Access Compliance Report

Public Rights-of-Way

(Curb Ramps)

Intersection ID: 49240	Main Street: HUBBARD FALLS DR	Cross Street: TOXAWAY LN	Location:	N
ADA ID: E753CFDB0A69	Ramp Type: Perp	Initial Pass/Fail: Fail	Overall Compliance: No	Severity Score: 25
Codes/Mitigation Info/Possible Solution		Field Measurements/Component Compliance

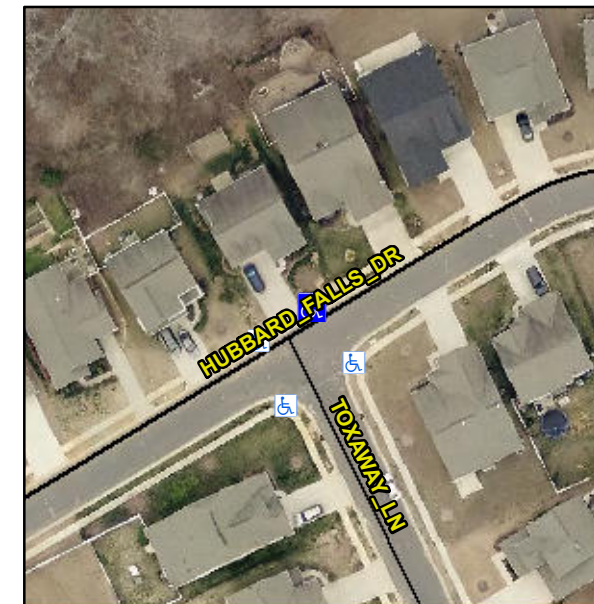
Not Found, R304.2.2

Compliance	Description	Data	Compliance	Description	Data
N/A	Ramp Length (in)	47.5	No	Ramp Slope (%)	13.6
Yes	Ramp Width (in)	48.0	Yes	Ramp XSlope (%)	0.2
N/A	Flare Type LT	N/A	N/A	Flare Type RT	N/A
N/A	Flare Slope LT (%)	N/A	N/A	Flare Slope RT (%)	N/A
N/A	Flare Traversable LT?	N/A	N/A	Flare Traversable RT?	N/A
N/A	Landing Length (in)	N/A	N/A	DWS Provided?	N/A
N/A	Landing Width (in)	N/A	N/A	DWS Contrast?	N/A
N/A	Landing Slope (%)	N/A	N/A	DWS Length (in)	N/A
N/A	Landing X Slope (%)	N/A	N/A	DWS Full Width?	N/A
N/A	Landing Curb? (Y/N)	N/A	N/A	DWS Offset (in)	N/A
N/A	Shared Landing?	N/A			
N/A	Gutter Ponding?	N/A	N/A	Gutter Slope (%)	N/A
N/A	Gutter Lip Ht (in)	N/A	N/A	Gutter X Slope (%)	N/A
N/A	Painted X Walk1?	No	N/A	Painted X Walk2?	N/A
	X Walk 1 Direction	To S		X Walk 2 Direction	N/A
N/A	X Walk 1 Width (in)	N/A	N/A	X Walk 2 Width (in)	N/A
	X Walk 1 Slope (%)	3.3		X Walk 2 Slope (%)	N/A
	X Walk 1 X Slope (%)	0.1		X Walk 2 X Slope (%)	N/A

Remove & Replace Entire Ramp.
